# RESPONSES TO COMMENTS

### 1.1 RESPONSES TO COMMENTS ON THE DRAFT IS/MND

Subject: Lopez Canyon Equestrian Trails and Trailhead Project  
SCH#: 2016091072

Figure A-2: Local Vicinity and Project Site APNs

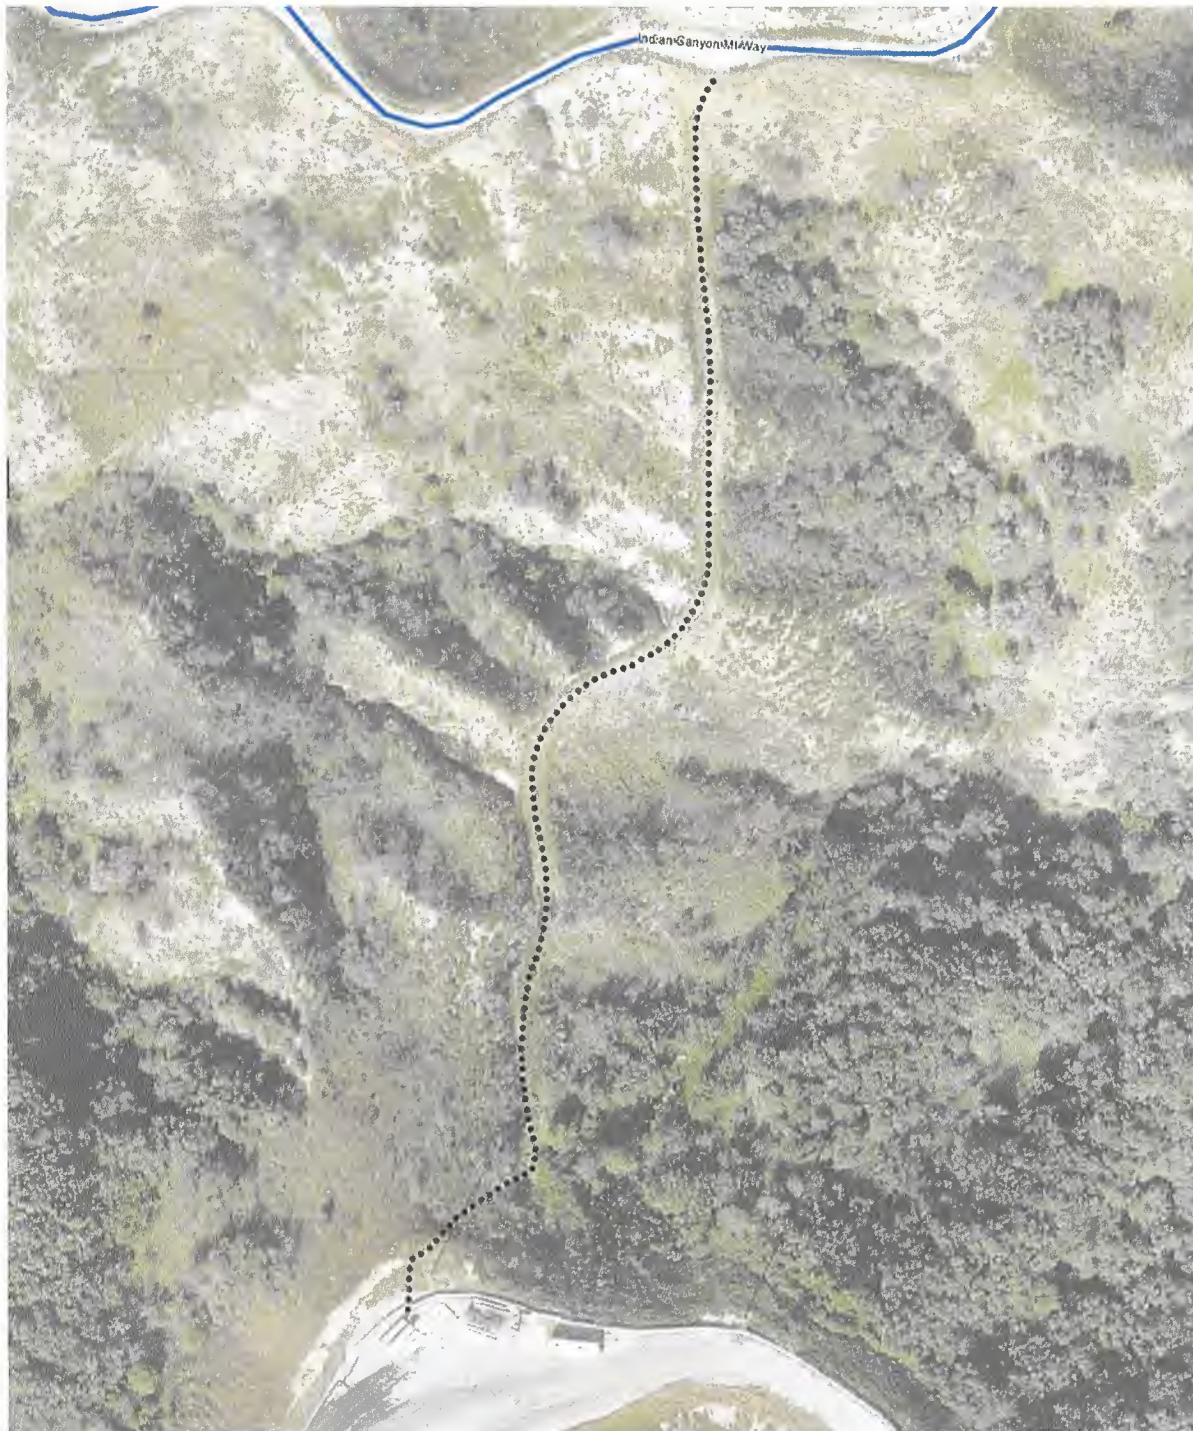
1<sup>st</sup> Our property, lot APN 2846003006 as noted on your proposal page A-3, includes a large portion of the shooting range that is used by our members and for law enforcement training. This canyon terminates at the ridge line where you are proposing a new trail identified as Future Connection # 1, as shown on page A-11, Figure A-5, that trail runs north from the landfill site and connects with Indian Canyon Mountain Way.

- LeCompte1-2 LASAN notes the comment's opposition to the trail alignment proposed for Future Trail Connection 1 and presented in Figures A-3 and A-5 of the Draft IS/MND; however, not the overall goal and objective of the project. Please refer to Response ICLC-4.

- ICLC-6 LASAN notes that traveling west along the Indian Canyon Mountainway Trail would result in users encroaching onto ICLC's property. As provided in Figure A-3 of the Draft IS/MND, LASAN's proposed trail loop would traverse east at the northern end of Future Connection 1 and away from ICLC's property. As provided in the Final IS/MND, LASAN is no longer pursuing Future Connection 1 as part of the project.

- LeCompte1-4 LASAN appreciates the commenter's willingness to better inform representatives from LASAN of the concerns raised as part of the trail's current alignment. As provided in Response ICLC-5, LASAN is no longer proposing Future Connection 1 in conjunction with the project.

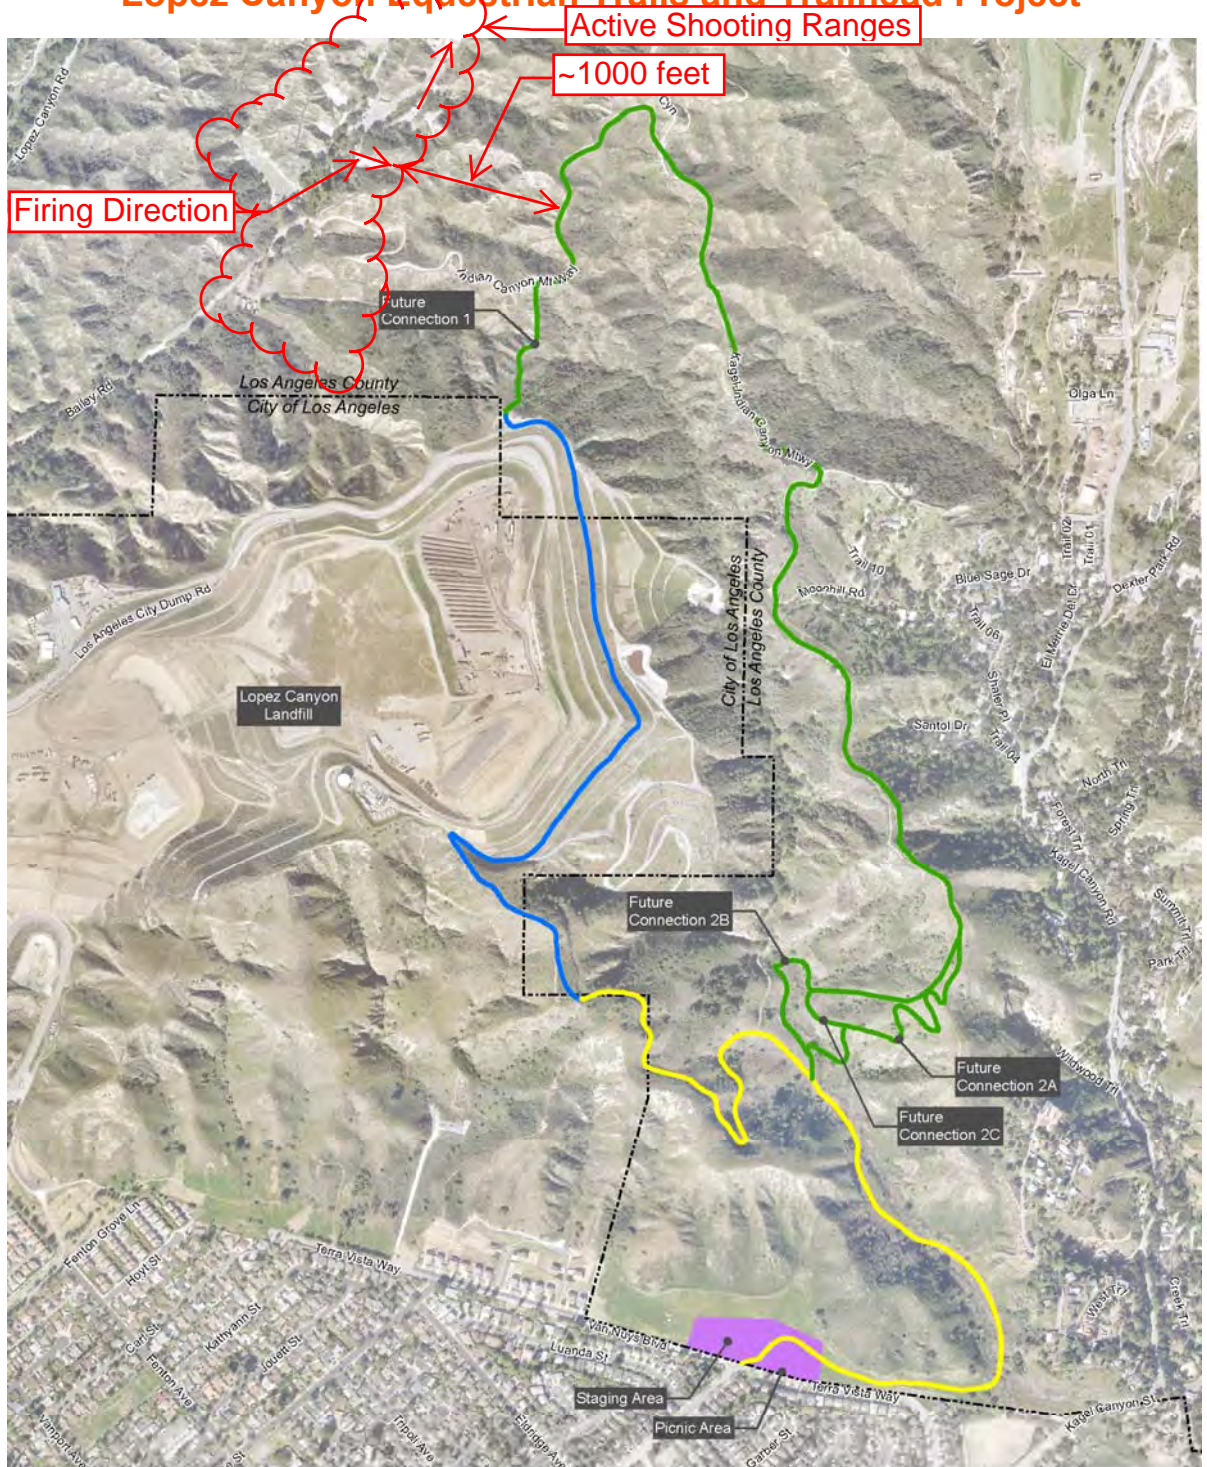
We do own a horse, but we would not consider riding on the northern portion of the Phase 3 trail knowing the close proximity of the shooting range.

See attached trailhead project map with comments.
